**TCN - 06**

Ref: PSER:SCT:DGP-C807:TCN-06

| Sub | Tender change notice (TCN) 06.  |
| Job | (i) Package-A: Civil, structural, architectural work etc job of Power Block-1; civil work of switch yard and (ii) Package-B: Civil, structural, architectural work etc of Power Block-2 for unit # 1 & 2 for 2x500 MW unit # 1 & 2 Durgapur Steel TPS, West Bengal. |

### EQUIPMENT EARTHING DETAILS WELDING DETAIL

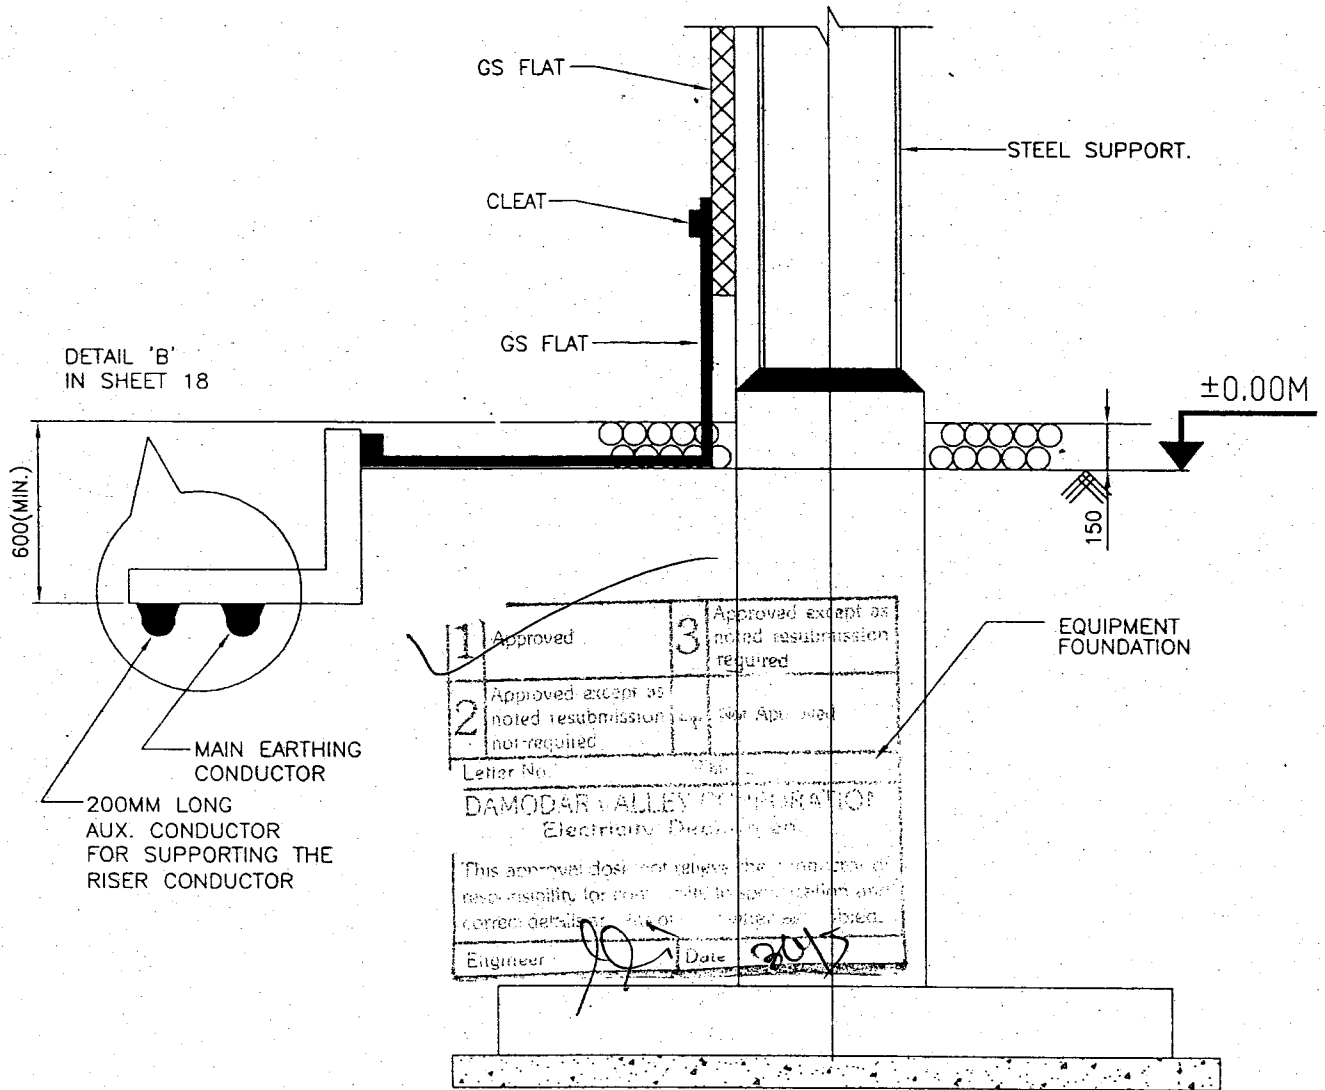
| SL NO | VOLUME, CLAUSE NO                 | CLARIFICATION/ MODIFICATION   |     |    |
|-------|-----------------------------------|---|-----|----|
|       | 118.0                             | Laying of underground earthmat of 40 mm dia MS rods at a depth of 600 mm to 800 mm from top of ground including following works.<br>- Excavation of trenches as per approved earthmat layout drawing.<br>- Layout of MS rod as per approved earthmat layout drawing.<br>- Welding of rods (as per drg no TB-4-240-316-108, sh no 16, 17 & 18, Rev-0 for welding details of rods).<br>- Bringing out rises just below gravel level near the equipment foundations.<br>- Back filing of soil.<br>- Any other work necessary to complete the laying of earthmat. | 105 | MT |

EQUIPMENT EARTHING DETAILS  
 AUXILIARY EARTH MAT FOR ISOLATOR MAIN MECH. & E/S  
 MECH. BOX (TYP.)

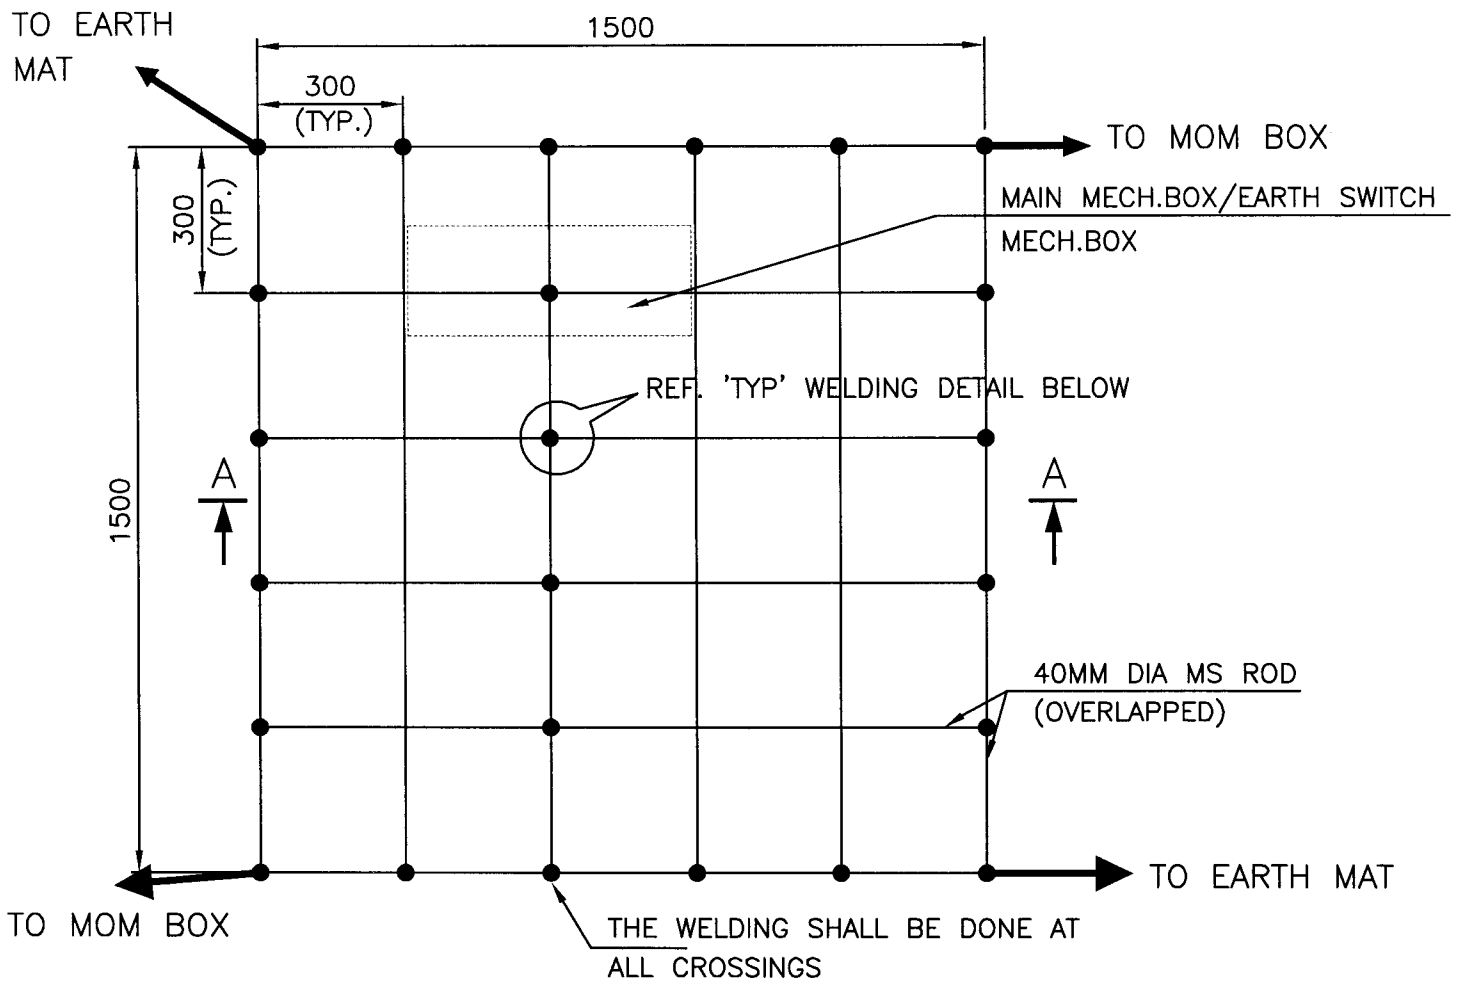
| SL NO | VOLUME, CLAUSE NO                 | CLARIFICATION/ MODIFICATION   |     |    |
|-------|-----------------------------------|---|-----|----|
|       | 119.0                             | Fabrication & laying of auxiliary mat of 40 mm dia MS rods at a depth of 300 mm from top of FGL including excavation & back filling as per drg no TB-STD-316-Auxiliary Mat, Rev-0. Any other work necessary to complete the laying of earthmat.   | 246 | NO |

**EQUIPMENT EARTHING DETAILS**  
**ROD EARTH ELECTRODE WITH TEST PIT**

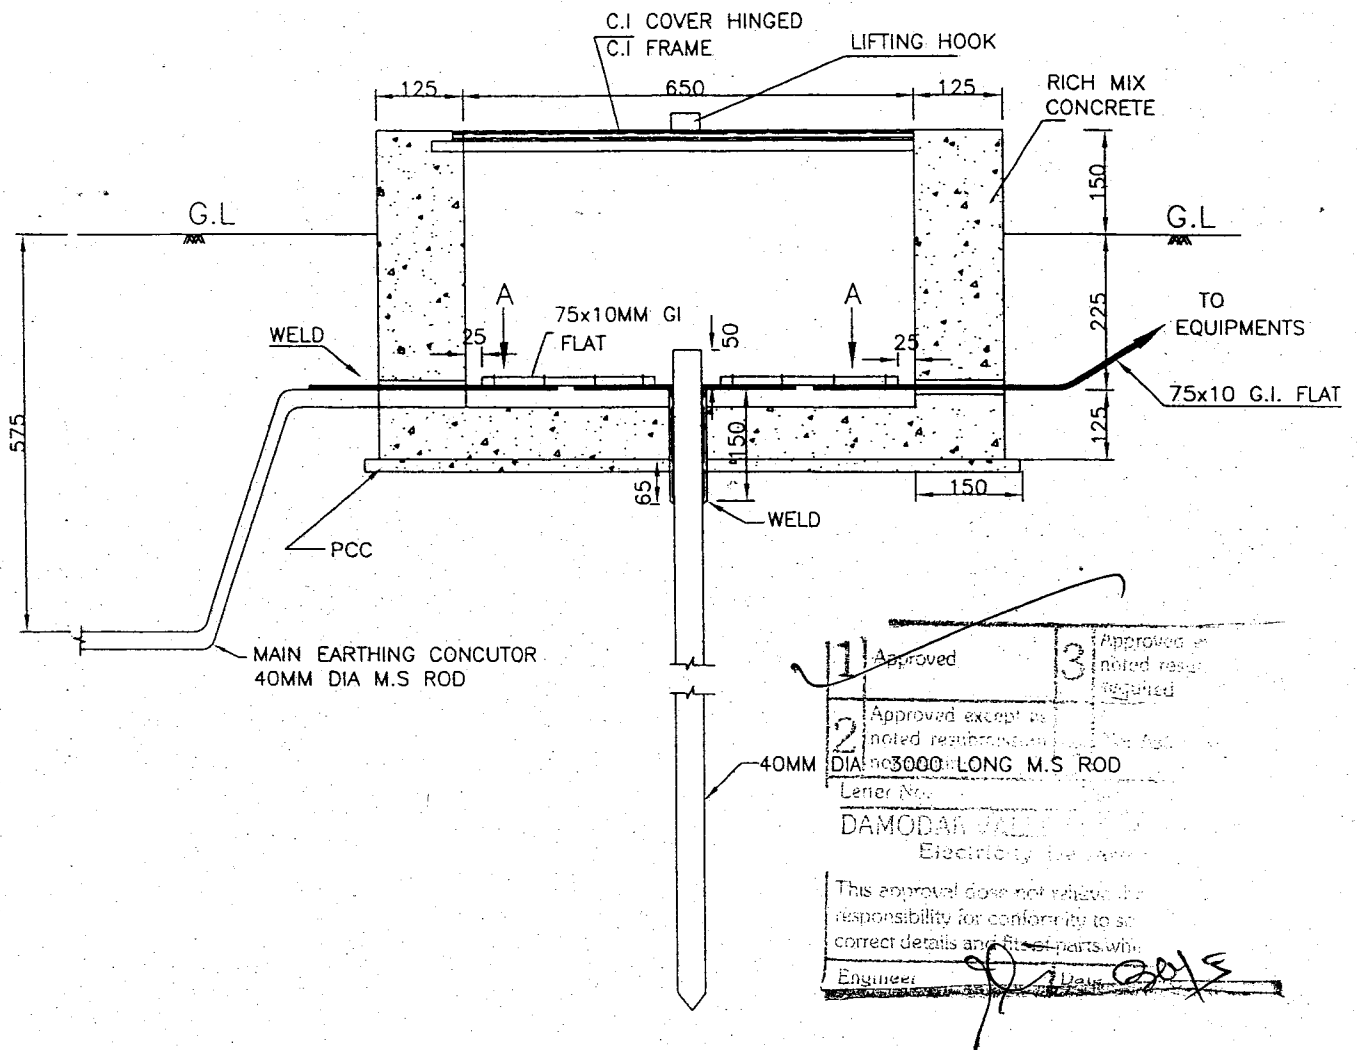
| SL NO | VOLUME, CLAUSE NO                 | CLARIFICATION/ MODIFICATION   |     |    |
|-------|-----------------------------------|---|-----|----|
|       | 120.0                             | Installing of 40 mm diameter rod electrode with test pit as per drg no TB-4-240-316-108, sh no 11, Rev-0 including following works.<br>- Excavation.<br>- Installing the rod electrode.<br>- Backfilling and compaction.<br>- Casting the test pit with cast Iron covers.<br>- Any other work necessary to complete the work.   | 8   | NO |
